DATE:	**March 03, 2025**
TO:	**All Bidders**
PROJECT:	**RFQ CCC-087** **PE Complex Re-Bid**
SUBJECT:	**ADDENDUM #2**

COMPTON COMMUNITY COLLEGE DISTRICT
RFQ CCC-087 PE Complex Re-Bid
RFC Questions Answers
Addendum #2

COMPTON COLLEGE PE COMPLEX REPLACEMENT
ADDENDUM 2 CONSOLIDATED CHANGES NARRATIVES

19 VOLLEYBALL FLOOR SLEEVE DETAIL
1 1/2" = 1'-0"

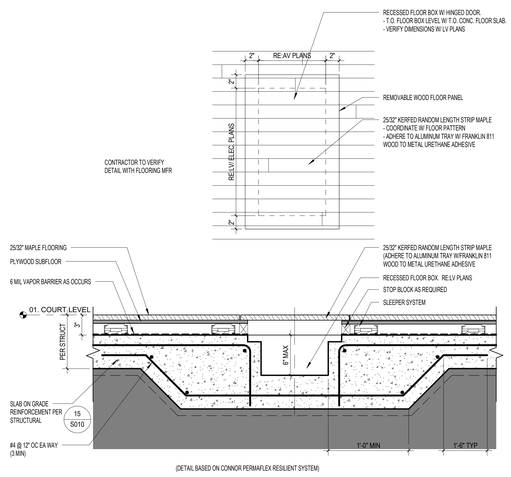
SHEET N0.	DESCRIPTION
SPECIFICATIONS	
00 01 10 Table of Contents	Removed Sections 10 22 39 FOLDING PANEL PARTITIONS, 13 31 00 FABRIC STRUCTURE and 23 05 00 MODULAR CENTRAL PLANT from the project.
03 35 00 Concrete Finishing	Added an exterior sealer to Section and reference to 03 30 00 for finish of exterior concrete stairs, landings and platforms.
05 12 13 Architecturally-Exposed Structural Steel	Updated Section to clarify that AESS Category 4 is not used on this project.
13 11 06 - Swimming Pool Equipment	Strikethroughs removed.
32 31 22 Galvanized Chain Link Fencing	Updated Section to include Fabric Wind Barrier (FA-2)
32 33 13 Exterior Bicycle Racks and Lockers	Updated Section to include bicycle rack capacity.
CIVIL	
C1.01 - TITLE SHEET AND GENERAL NOTES	The Paving note on sheet C1.01 is revised to align with details and soils report.
ARCHITECTURAL	
A101A - PRACTICE COURTY LAYOUT	"NIC" removed from detail 19 after "Volleyball Post"

1 HIGH & LOW ROOF PLAN
1/8" = 1'-0"

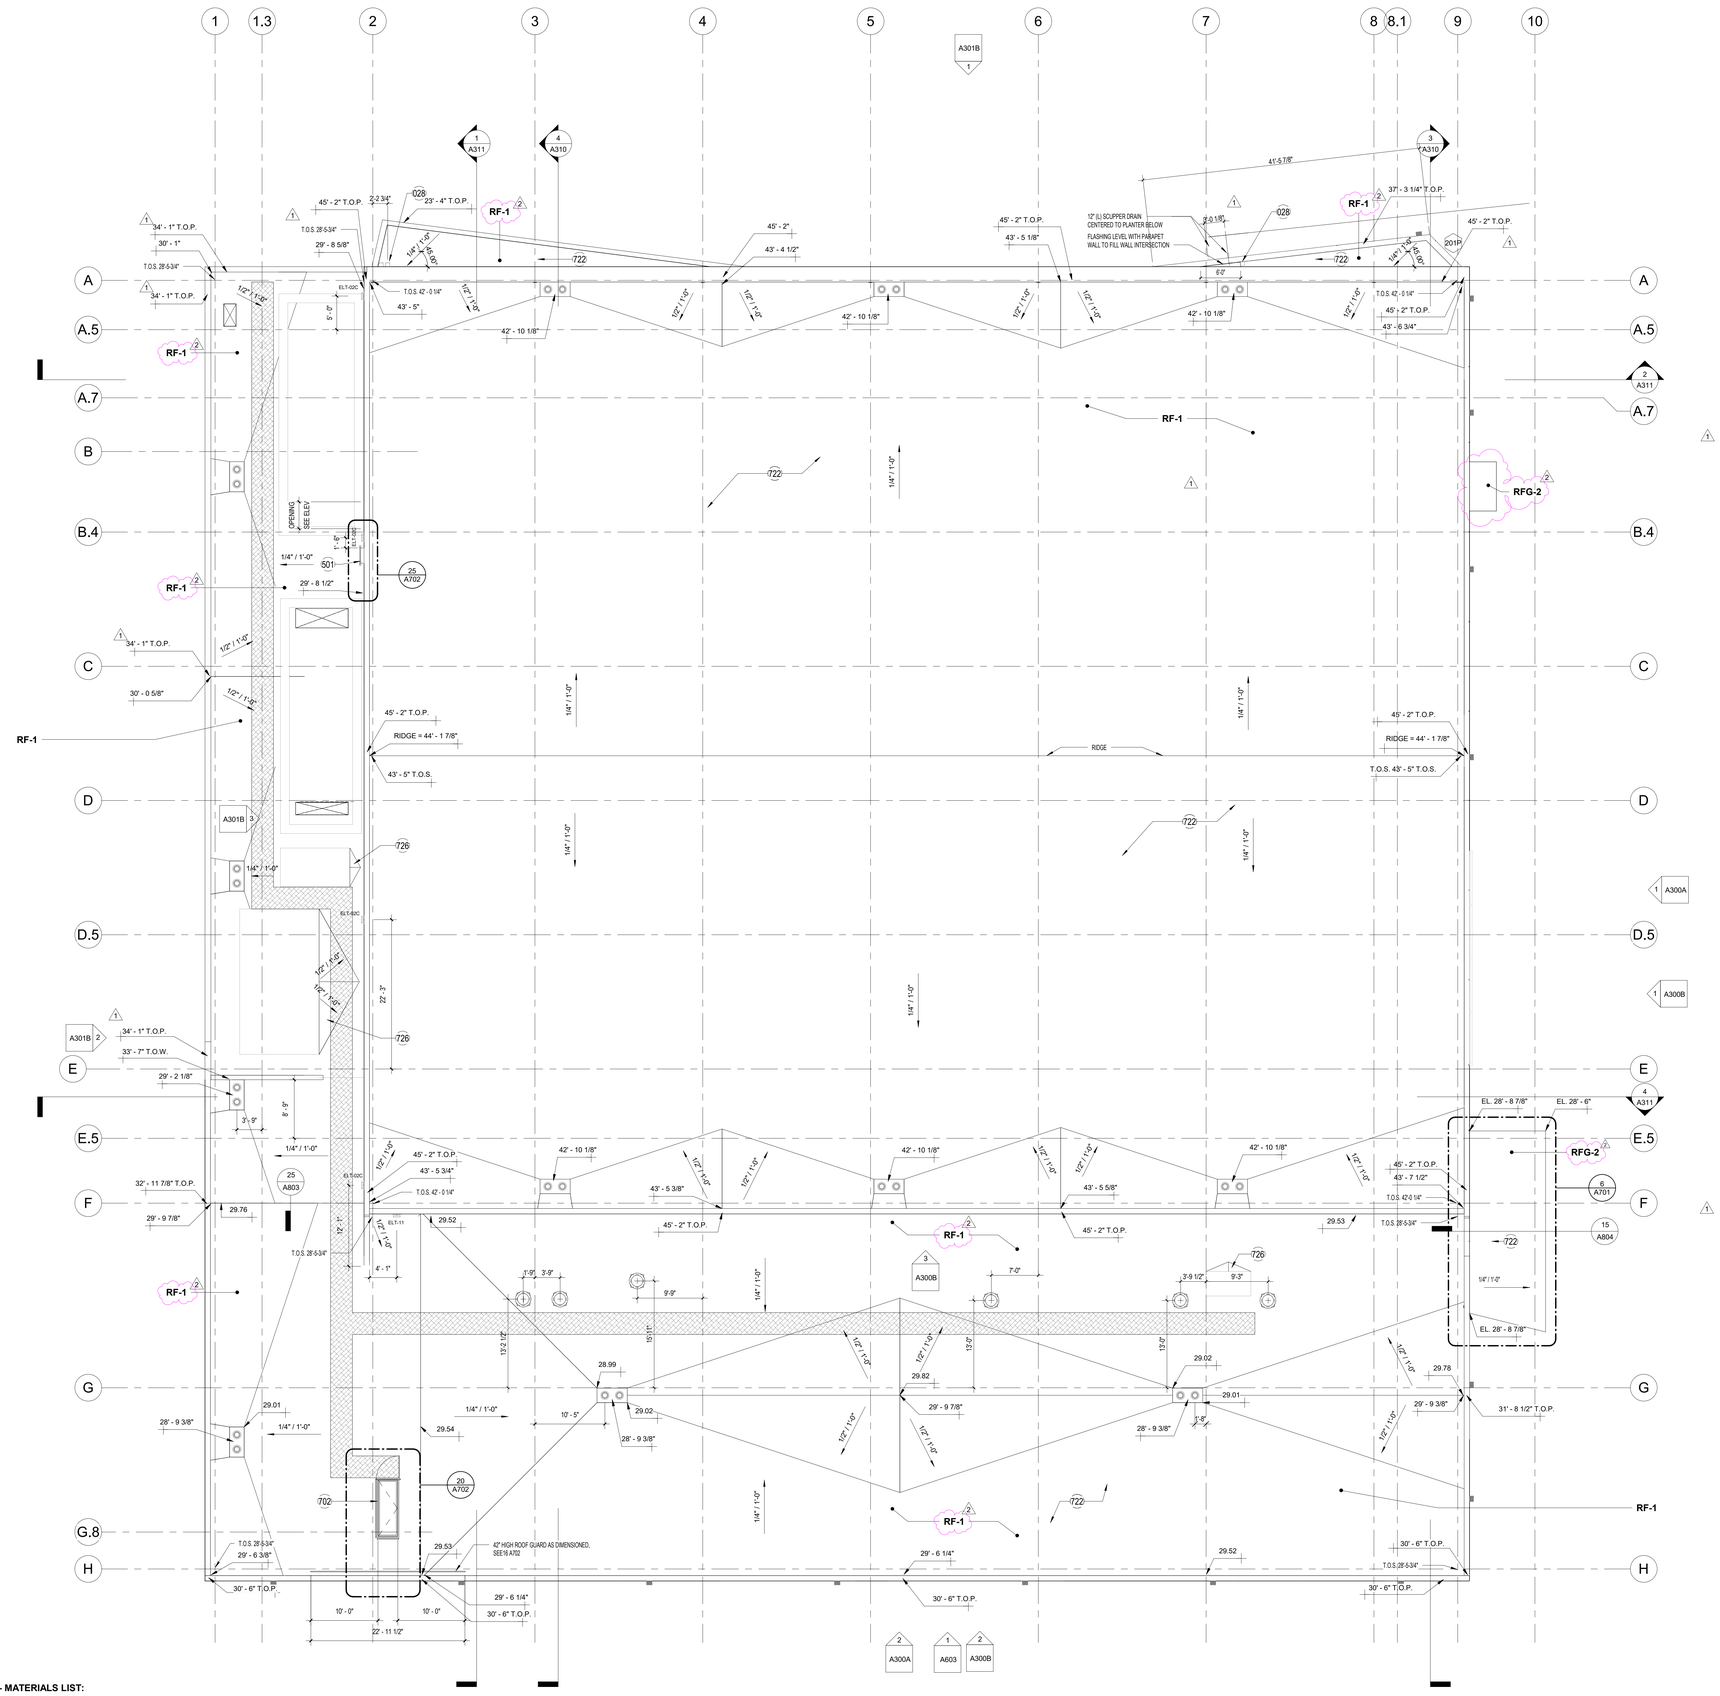
33	Please clarify where does 'RF-1' (white), and 'RFG-2' (reflective gray) on A103 Materials List apply on the roof area.	A103		RF-1 located at primary High and Low roof as noted on A103. RF-1 located at the two canopies on the north side. RF-1 located at top of Pool house roof. RFG-2 at the two canopies on the west side as noted in 15&16/A804. See addendum with added material callouts for clarification. (Struere)
34	Refer to Specification 051200, section 1.05.C. Please clarify size and components of architecturally exposed structural steel mock-up per section 1.05.C		Specification 051200	Size of mock up to be left in place shall be full size of the element(s). Size of mock up elements not intended to remain in place shall be of sufficient size to adequately convey the workmanship of finished product. (BJSCE)
35	S003-Structural Steel Note #4 & #9 noted any fabricator supplying more than 1 Ton of steel shall be AISC certified. Specification 051200 does not have this requirements. Is AISC certified fabricator a mandatory requirement? Would owner also accept LADBS certified steel fabricator?	S003	Specification 051200	Yes No exceptions taken to use of LA Certified Fabricator (BJSCE)

A103 - ROOF PLAN	Additional roof material tags added for clarity of location. Level 1 entrance canopy graphics added for clarity.
A111 - POOL AREA PLAN	Roof material tag added to Pool House roof for clarification.
A131 - LEVEL 1 FINISH PLAN	Keynote 15 updated to clarify FRP installation location
A132 - LEVEL 2 FINISH PLAN	Keynote 15 updated to clarify FRP installation location
A300A - EAST / SOUTH ELEVATIONS	FA-2 Material description revised.
A301A - NORTH / WEST ELEVATIONS	FA-2 Material description revised.
A412 - ENLARGED RR PLANS & ELEVATIONS	"By others" removed after "Swimsuit dryer location" on elevations 3 & 5
A711 - DETAILS - NORTHEAST BENCH	Detail 5 graphics revised to show correct bike rack size.
A803 - EXTERIOR DETAILS	Notes added to details 1 & 2 regarding sheet metal flashing.
A905 - INTERIOR DETAILS	"(By Others)" text removed from details 22, 23, & 24.
CURTAIN WALL	
CW0.01 - COVER PAGE	Door types A and B labels corrected to match Architectural drawings. No change to scope

1 ULT5920 JAMB DETAIL
Arch Ref: 16/A902
Shop Ref: 206E/3.21, 206W/3.21

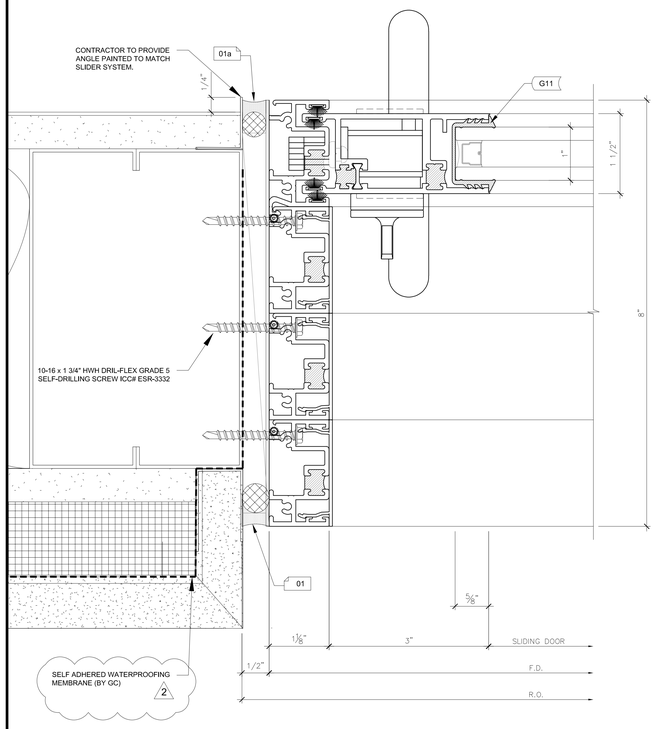
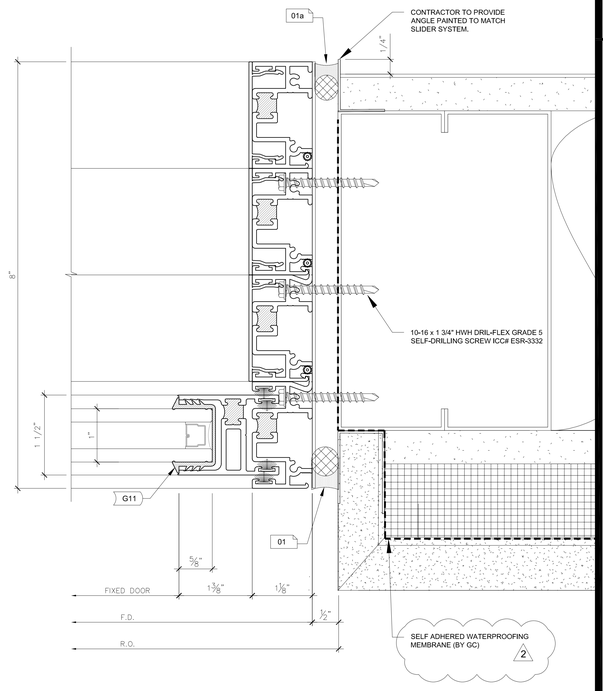
CW3.34 - AF450 INTERIOR ELEVATION	Door 205 revised to match Architectural drawings (Solid wood door w/ alum. Frame)
CW5.21 - ULT5920 PLAN DETAILS	"By Others" replaced with "By GC" on details 1 & 3.
LOW VOLTAGE	
LV102 - LOW VOLTAGE - LEVEL 2 FLOOR PLAN	Emergency communication system (note 12) added. Callout added at Stair #2 landing.
LV101 - LOW VOLTAGE - LEVEL 1 FLOOR PLAN	Exterior WAP's added
LV101P - LOW VOLTAGE -POOL AREA PLAN	Exterior WAP added to pool building.
POOL	
SP.3 - SWIMMING POOL UNDERWATER LIGHT / TIMING SYSTEM PLAN	"By Others" revmoved after "ethernet drop". Within GC scope.
